8 November 2017

DEXUS QUARRYWEST PROJECT (SSD 6801) – SECTION 96 MODIFICATION (MOD 5) – STATEMENT OF ENVIRONMENTAL EFFECTS

Figure 4: QuarryWEST Precincts C and D Site Plan – As Proposed

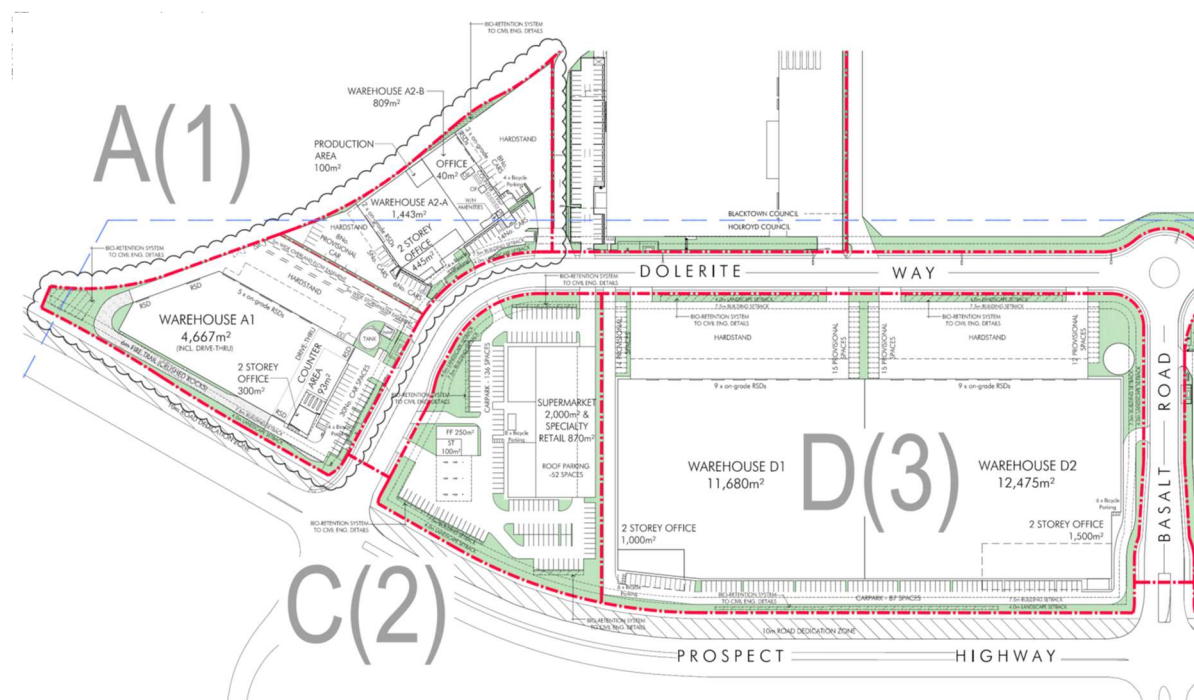
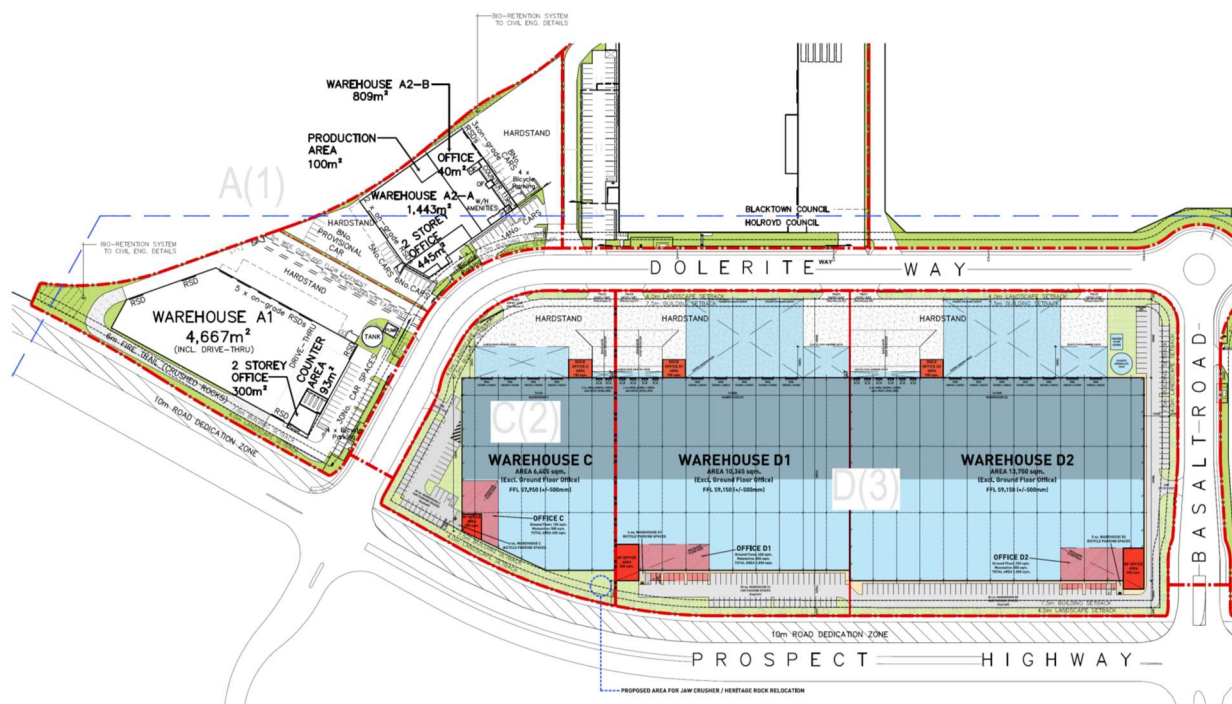
Precinct D is proposed to be developed for warehousing and distribution purposes, in a similar manner to the approved warehouse and distribution facilities in this precinct. Some relatively minor changes to the layout of the approved facilities are proposed.

Consequently, DEXUS is now proposing to develop Precinct C for warehouse and distribution purposes, consistent with the predominant land use within the QuarryWEST Estate, and the QuarryEAST Estate.

- allow Precinct C to be used for warehouse and distribution purposes; and
- amend the internal masterplan layout in Precincts C and D, including:
 - deletion of the retail facilities in Precinct C, and replacing them with a warehouse and distribution facility (Warehouse C);
 - minor amendments to the footprint and layout of the warehouse and distribution facilities in Precinct D (Warehouse D1 and Warehouse D2);
 - a relatively minor increase in total floor area for the estate, associated with the proposed warehouses; and
 - minor changes to accesses, internal circulation and parking layout.
